**OCCIDENTAL MINDORO ELECTRIC COOPERATIVE, INC.  
SAN JOSE, OCCIDENTAL MINDORO**

**BID BULLETIN NO. 07**

This Bid Bulletin No. 07 dated 31 October 2019 is being issued to respond to request for clarifications and to confirm key issues addressed and discussed during the Pre-Bid Conference held last 03 October 2019:

Single Line Diagram: Interim Demand Requirement 2020-2022

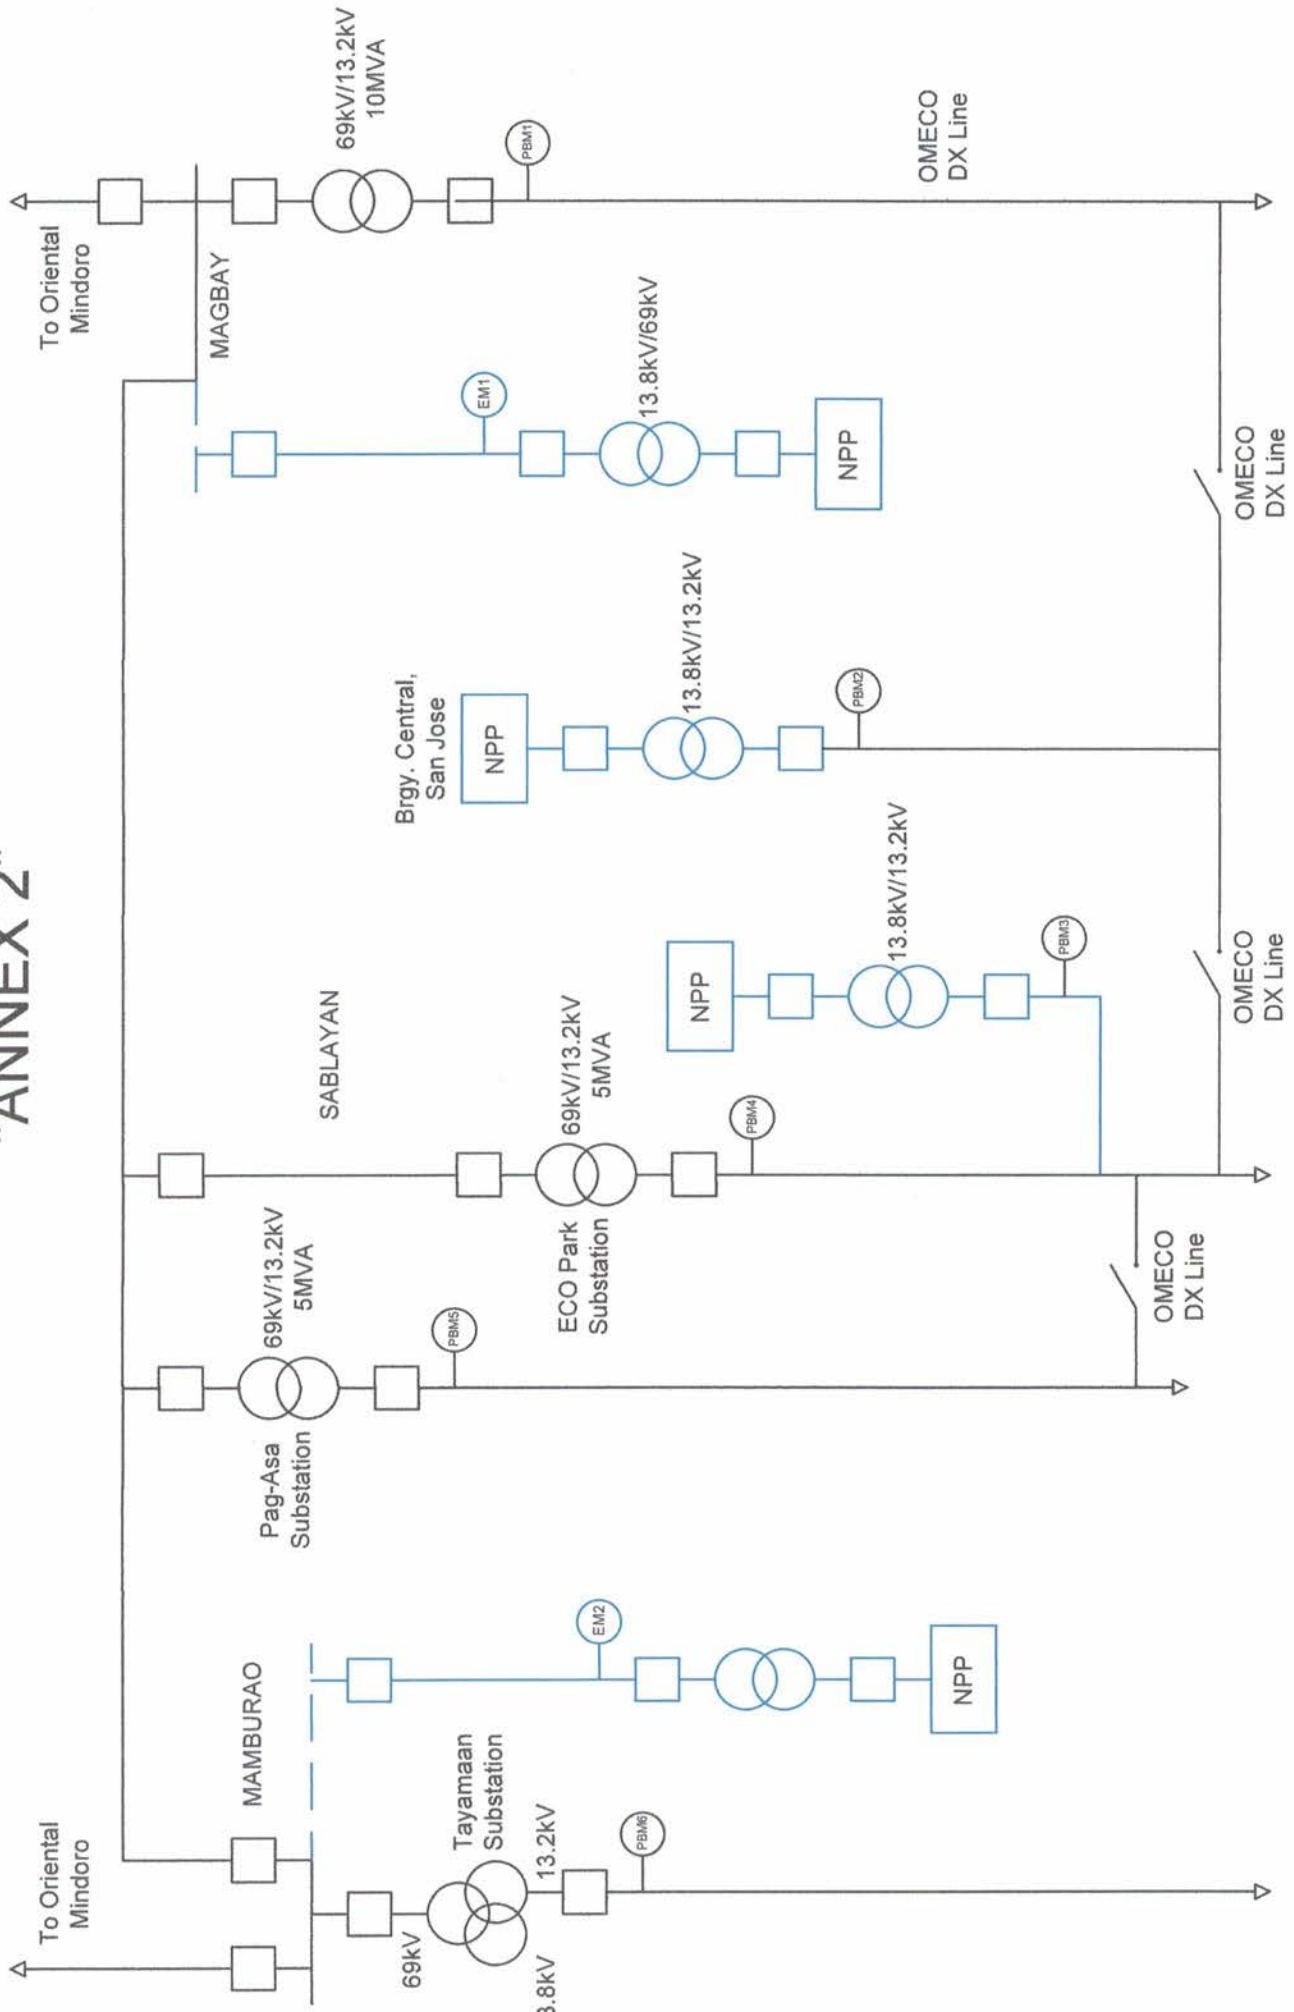
REFERENCE	QUESTIONS AND CLARIFICATIONS	TPBAC RESPONSE
	<p>separate metering facilities for both 13.2kV and 69kV?</p> <ul style="list-style-type: none"> <li>• We understand that as per regulation the metering facility is at the injection point. Moreover, under Section 7.2.h the Seller is required to connect to both 69kV and 13.2 kV while Section 7.2.i requires the Seller to connect to the Buyer's metering point at 13.2kV. Please clarify.</li> <li>• ITB Section 1.5 requires that the winning bidder shall install 69kV metering facility between existing 69kV line of NPC and the winning bidder's power plant and interconnection facility. Will the 69kV metering facility requirement be a billing meter or a check meter?</li> <li>• Can we connect the back-up power plants to the 13.2 KV only? When the 69KV line breaks down, it will be useless to supply power in the defective system? Please note that we can also do regulation at the 13.2 KV system.</li> <li>• We understand that normally the metering facility is at the injection point. You mentioned that there will be separate billing meter for RE. Will the injection point be at 13.2kV or 69kV?</li> <li>• Per TOR item 17, Power Plant Substation/Switchyard shall connect to both 69 KV (NPC line) and 13.2 KV (OMEKO Dist. Line) However, per InsTB Section 1.4 the Power Bill</li> </ul>	<p>generation for UC-ME claims. Please refer to the attached Single Line Diagram (Annex 2 and Annex 4 of this Bid Bulletin).</p>
